S E R V I C E N O T E

6011A Autoranging DC Power Supply

Modification using RTV to prevent W8 Ribbon Cable disconnect.**Duplicate Service Notes:**

Figure 1

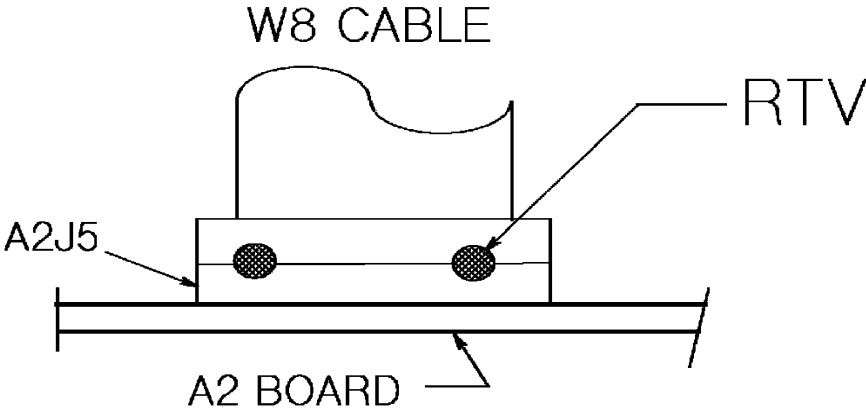
The W8 ribbon cable connecting the A1 main board assembly to the A2 Control board assembly may vibrate loose during transportation. This only involves units with serial numbers inclusive of those listed above.

Reconnect the W8 ribbon cable. Use RTV to secure the W8 connector to the J5 mating connector on the A2 assembly. Put a 8 mm (0.313 in) size spot bridging the W8 / J5 connectors. Bridge the connectors with an RTV spot at each end as shown in figure 1.
